Rezoning Transportation Analysis

Petition Number: 2025-088

General Location Identifier: 03126317

Date	Description
8-28-25	First Review (KC)

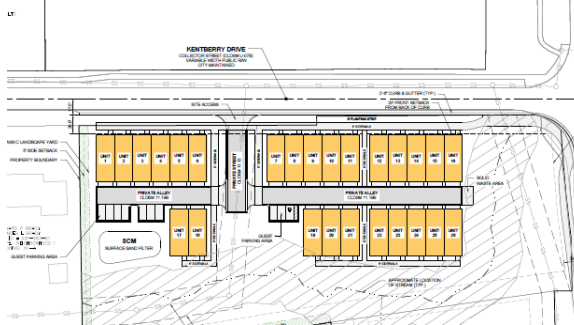
3. Revise site plan and conditional note(s) to commit to dedicate 33.5' of right-of-way from the road centerline along Kentberry Drive. The site plan shall label and dimension the right-of-way from the road centerline.
4. Revise site plan and conditional note(s) to commit to construct bicycle facilities by installing a 12' multi-use path along Bellhaven Boulevard in accordance with the council-adopted Charlotte Streets Map. Multi-use paths maintained by the City shall meet ADA/PROWAG requirements.

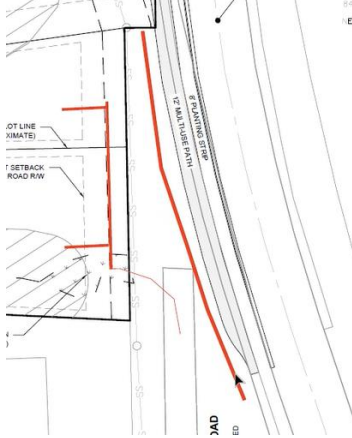
7. Revise site plan and conditional notes to have units access internal to site with a private alley. (i.e. closer to your original submitted site plan. (See below.)
